SUNDRY NOTICES AND REPORTS ON WELLS

8. Well Name and No.
CORRAL CANYON 8-32 FEDERAL 161H

XTO Energy, Inc. respectfully requests to change the casing design associated with this well from a 4-string to a 3-string design. This change updates the casing, cement program, and mud circulation system. Additionally, XTO Energy respectfully requests to batch drill these wells.

PECOS DISTRICT
DRILLING CONDITIONS OF APPROVAL

13-3/8" x 9-5/8" x 5-1/2" 10M RSH-2 Wellhead Assembly, With T-EBS-F Tubing Head

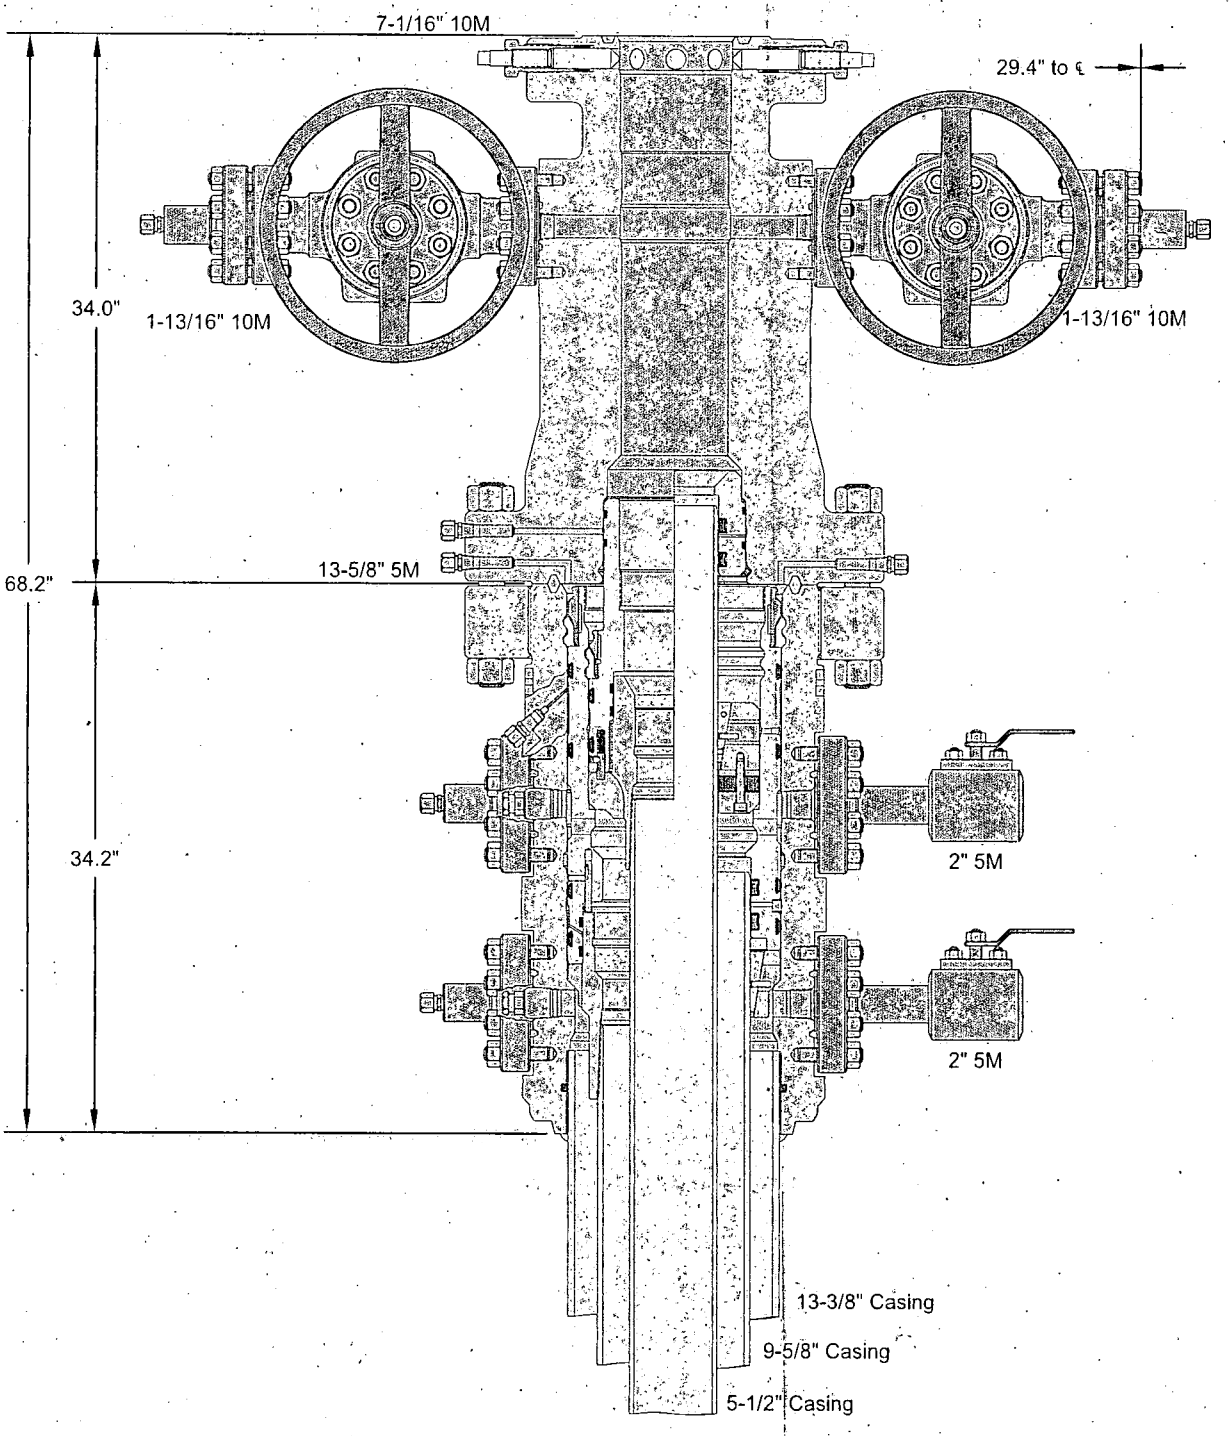
Permanent Wellhead – GE RSH Multibowl System

A. Starting Head: 13-5/8" 10M top flange x 13-3/8" SOW bottom
B. Tubing Head: 13-5/8" 10M bottom flange x 7-1/16" 15M top flange
- Wellhead will be installed by manufacturer's representatives.
- Manufacturer will monitor welding process to ensure appropriate temperature of seal.
- Operator will test the 9-5/8" casing per BLM Onshore Order 2
- Wellhead Manufacturer representative will not be present for BOP test plug installation

2. Operator has proposed a multi-bowl wellhead assembly. This assembly will only be tested when installed on the surface casing. Minimum working pressure of the blowout preventer (BOP) and related equipment (BOPE) required for drilling below the surface casing casing shoe shall be **5000 (5M)** psi.

a. Wellhead shall be installed by manufacturer's representatives, submit documentation with subsequent sundry.
    b. If the welding is performed by a third party, the manufacturer's representative shall monitor the temperature to verify that it does not exceed the maximum temperature of the seal.
    c. Manufacturer representative shall install the test plug for the initial BOP test.
    d. If the cement does not circulate and one inch operations would have been possible with a standard wellhead, the well head shall be cut off, cementing operations performed and another wellhead installed.
    e. Whenever any seal subject to test pressure is broken, all the tests in OOGO2.III.A.2.i must be followed.

11-14-16
XTO
Choke Line
Nor Am #25
DATE
BR B 0-15000-8-IH

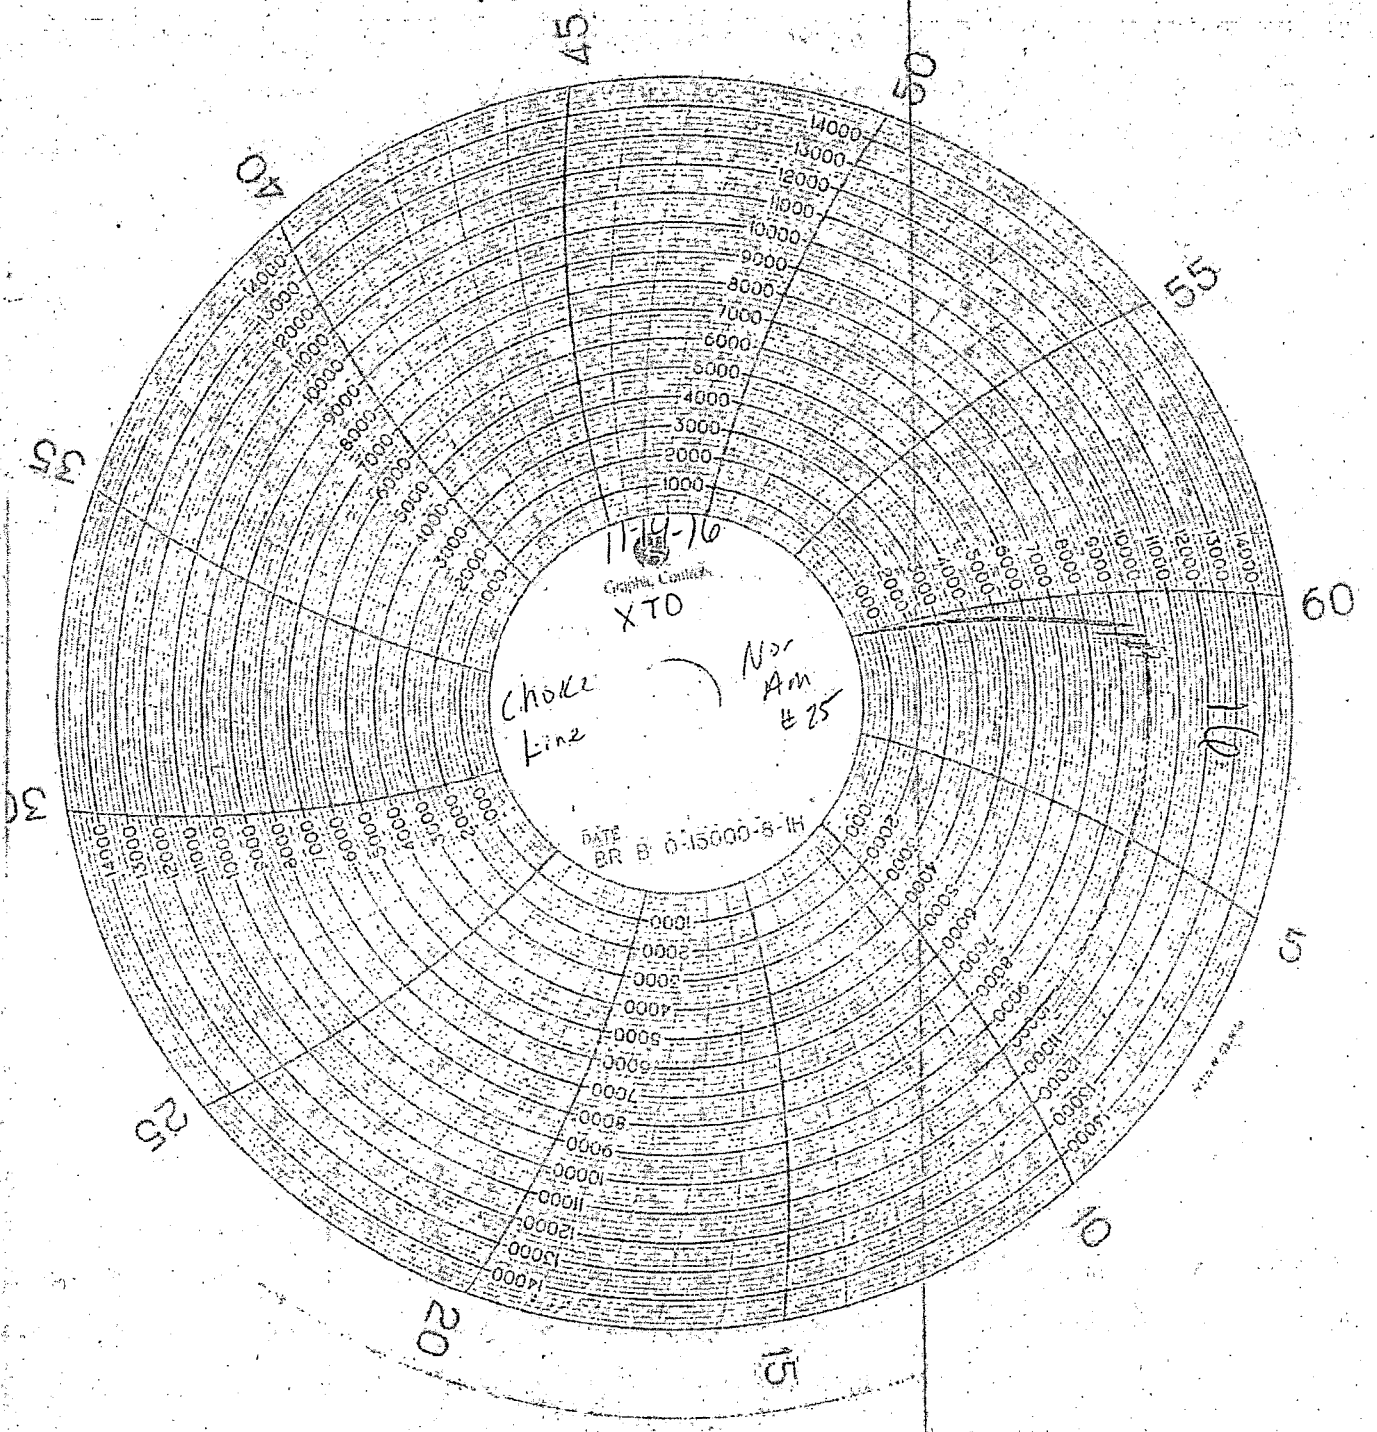
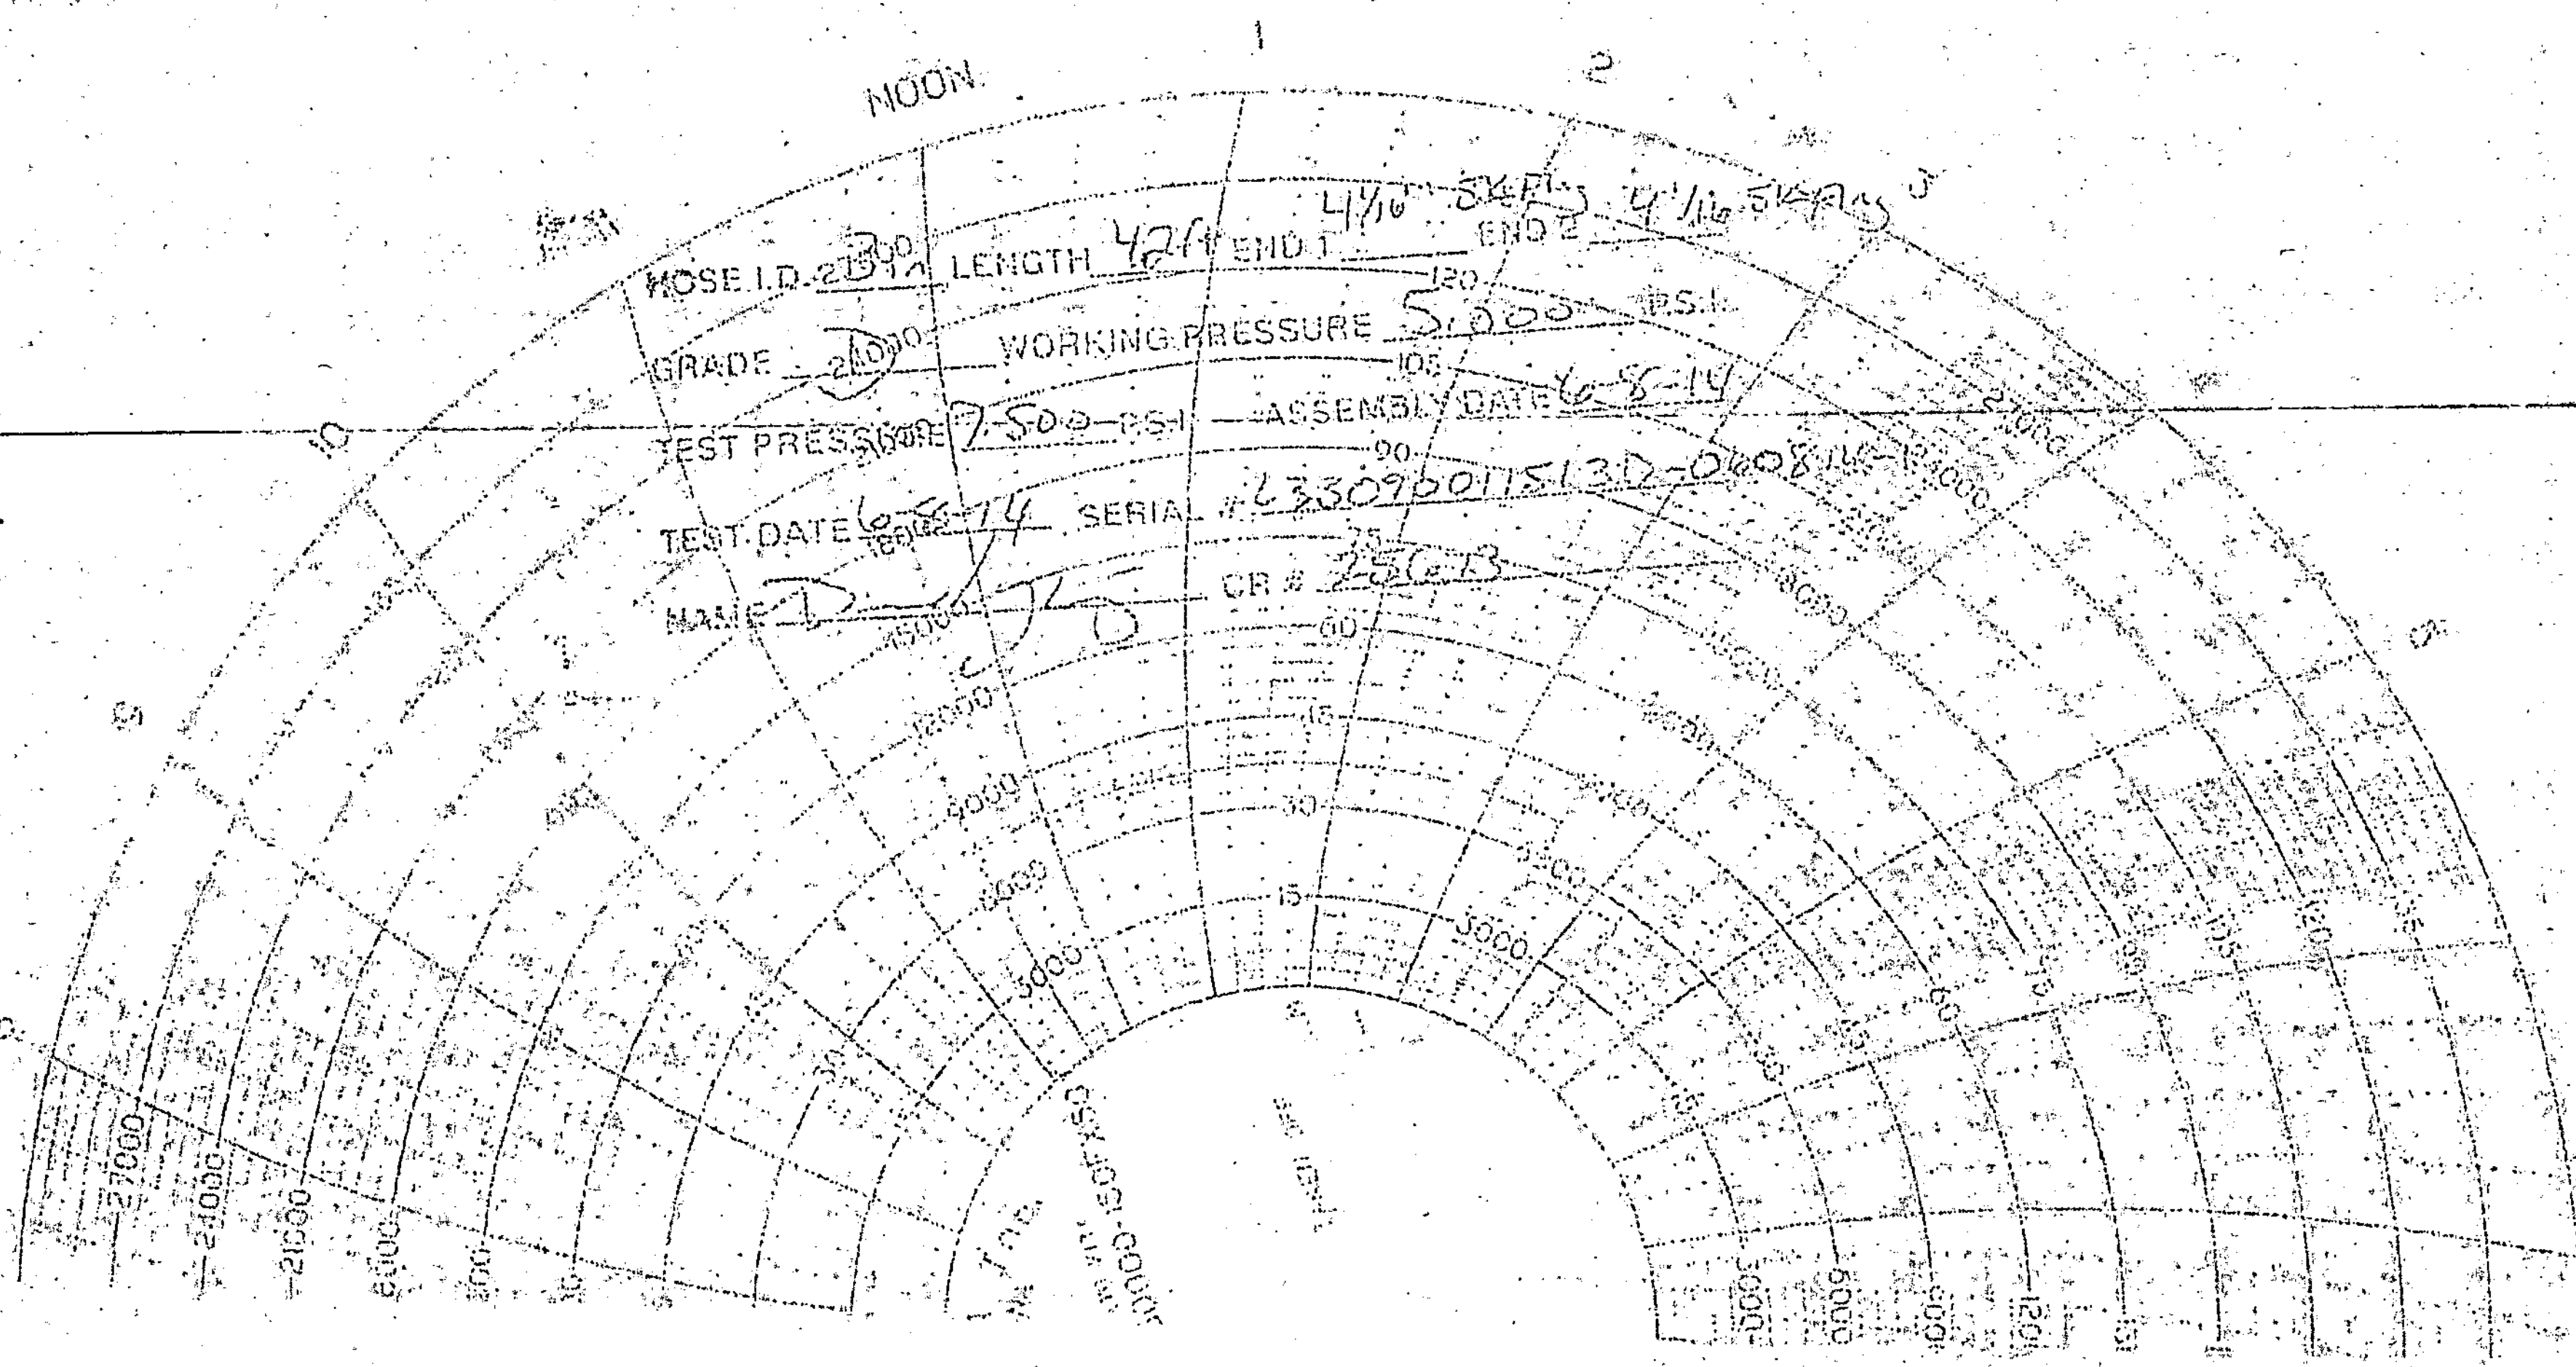
A variance is requested to allow use of a flex hose as the choke line from the BOP to the Choke Manifold. If this hose is used, a copy of the manufacturer's certification and pressure test chart will be kept on the rig. Attached is an example of a certification and pressure test chart. The manufacturer does not require anchors.

1. Variance approved to use flex line from BOP to choke manifold. Manufacturer's specification to be readily available. No external damage to flex line. Flex line to be installed as straight as possible (no hard bends).

2. A variance is approved for a flexible hose to be installed from the BOP to the choke manifold, the following requirements apply: The flex line must meet the requirements of API 16C. Check condition of flexible line from BOP to choke manifold, replace if exterior is damaged or if line fails test. Line to be as straight as possible with no hard bends and is to be anchored according to Manufacturer's requirements. The flexible hose can be exchanged with a hose of equal size and equal or greater pressure rating. Anchor requirements, specification sheet and hydrostatic pressure test certification matching the hose in service, to be onsite for review. These documents shall be posted in the company man's trailer and on the rig floor.
